The Municipality of
Powassan
The Heart of Good Living

**TENDER ADDENDUM
MAIN STREET-NORTH HILL**

**DESCRIPTION
ROAD RECONSTRUCTION**

ADDENDUM NO. 2 TO CONTRACT

2. Division 'C' – Page FT-6, Section E) Valley View Dr E Property Drainage:

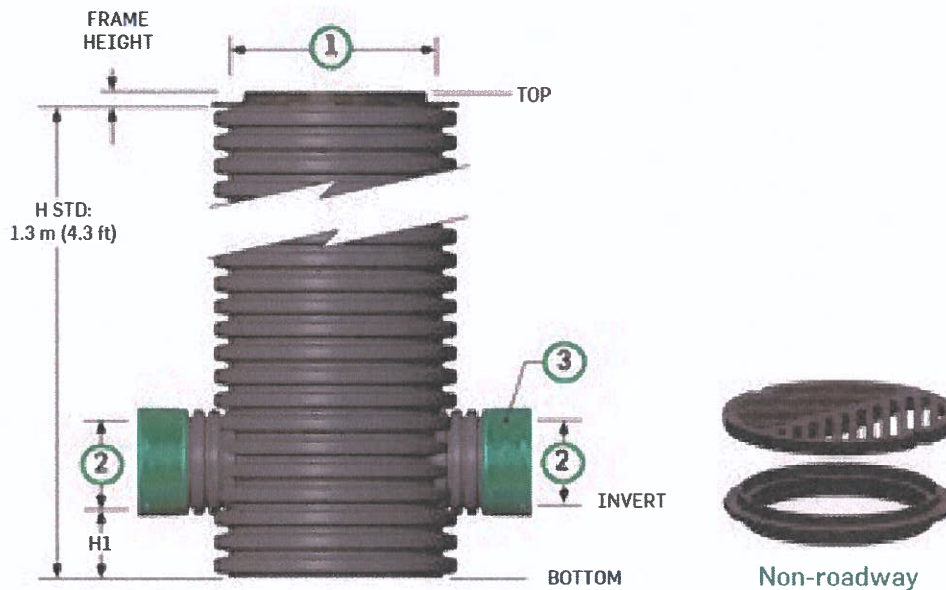
Item #E4: Storm Pipe c/w backfill materials; Est Qty= 16.5m shall be amended to the following:
Installation of storm pipes, catchbasins and manhole c/w backfill materials; Est Qty = 90m.

The Municipality of Powassan will supply the HDPE pipes and HDPE catchbasins/manholes (See contract drawings page RD1 construction notes) to be installed by the Contractor and the installation will be paid for under Item #E4.

For further clarification to the Contractor, the catchbasins and manholes will be of HDPE composition and will be completed with the installation of a cast iron grate (supplied by the Municipality). HDPE catch basins/manholes provided by the Municipality will be equivalent to SOLENO, see figure below.

As per statement, please replace the quantity in the Form of Tender from 16.5m to 90.0m
